**GOVERNMENT OF THE DISTRICT OF COLUMBIA  
DEPARTMENT OF GENERAL SERVICES**

**DESIGN-BUILD SERVICES  
PLAY AREAS AT FOREST HILLS PARK AND ROSE PARK**

**Solicitation #: DCAM-14-CS-0106**

**Addendum No. 6  
Issued: March 10, 2014**

## Sherwood Recreation Center Programmable Gate Locations

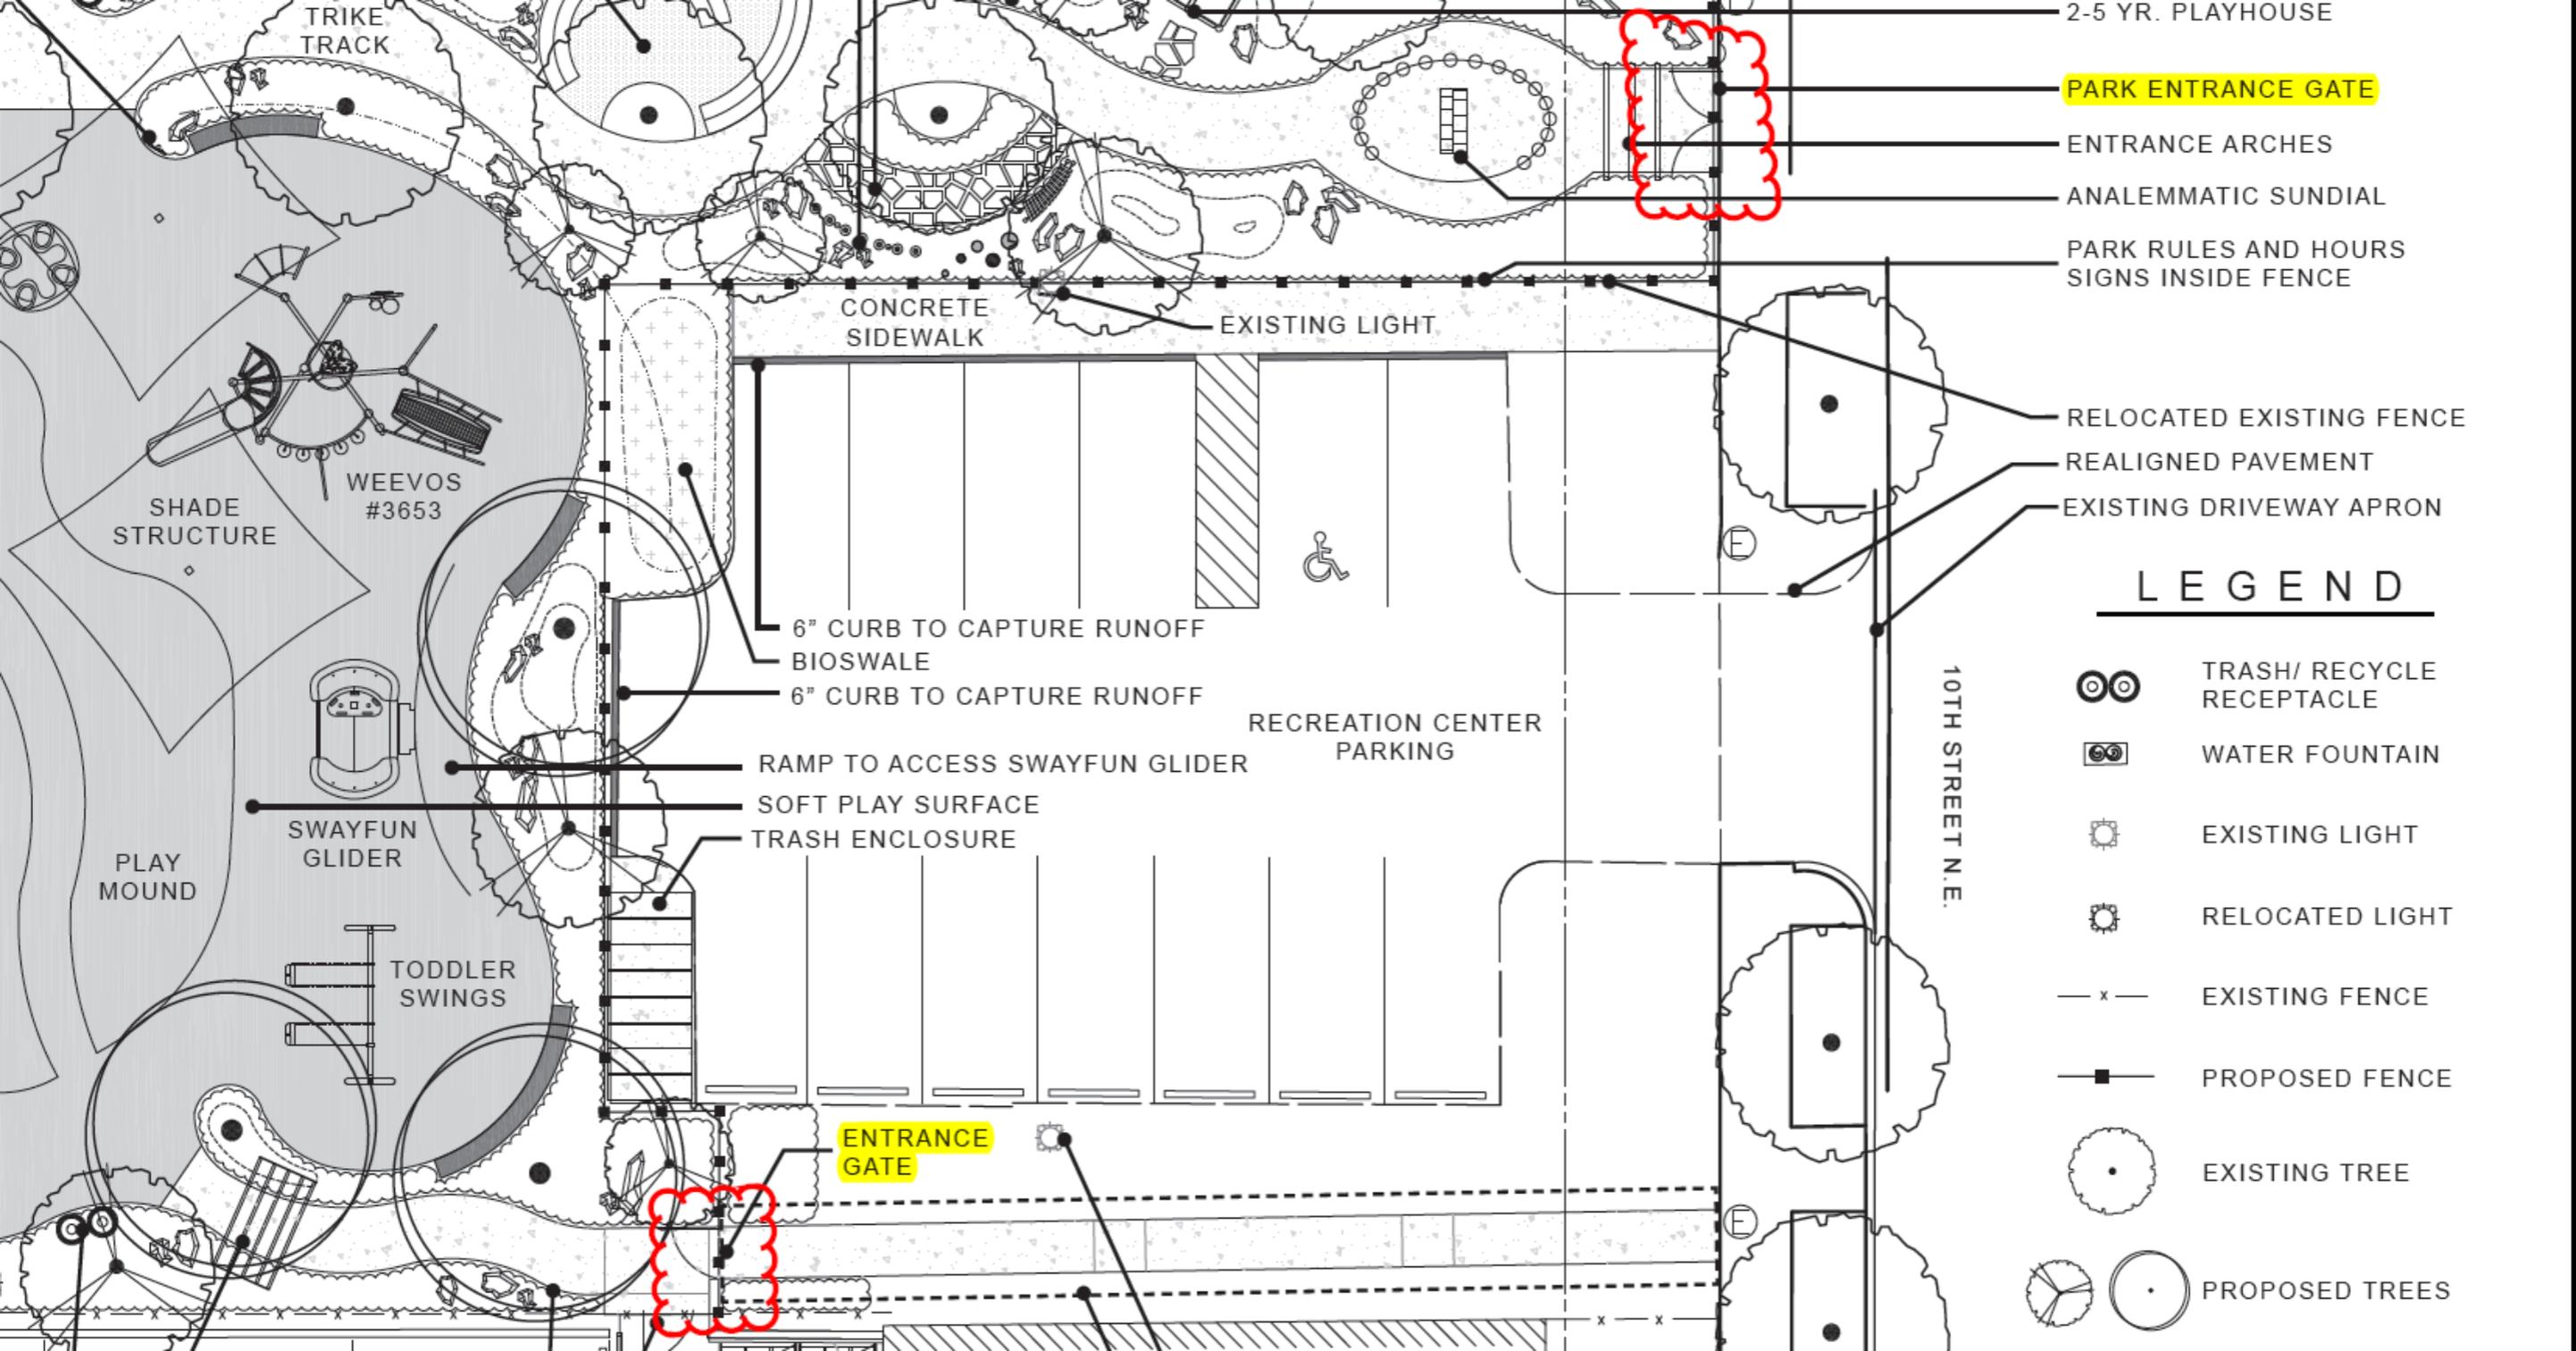
37. Please provide the two automatic entry gate locations. Multiple gates shown on conceptual, but plan does not indicate which ones are to become automatic gates. **Response: The proposed locations for the programmable gates are shown on the attached document. The existing gate between the school and the playground should remain as is. It does not need to be a programmable gate.**
